North Anna SLRA

RAI B2.1.7-1: Pitting and Crevice Corrosion in Reactor Vessel Internals

NRC Concerns

RAI B2.1.15-1:

Engine Installation History

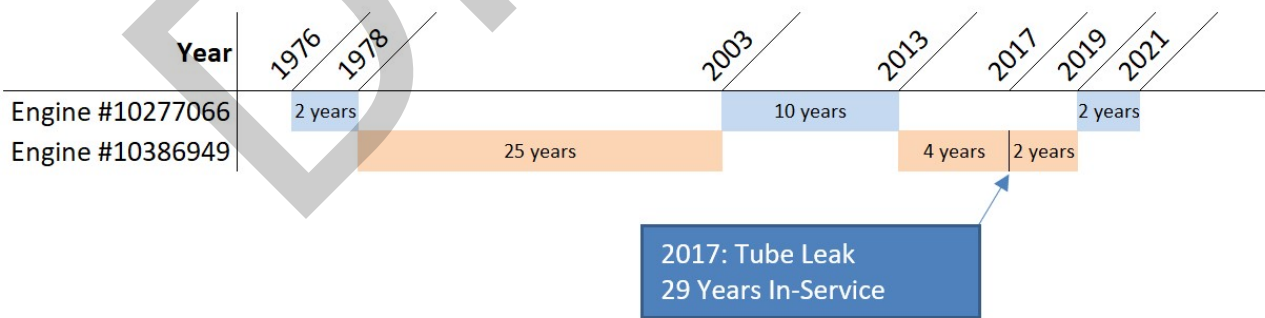
- Basis for 20 year periodic replacement frequency

- Two Diesel Assemblies have been in service for the Fire Pump application
 - Engine 1 (Serial #10277066) is currently installed with 14 years of in-service time. No HX OE.
 - Engine 2 (Serial #10386949) had 29 years in service before developing a HX tube leak.
- Dominion Energy believes that a 20 year replacement frequency is conservative based on two engines in service for over 40 years with one HX tube leak. No further actions are required for SLR.
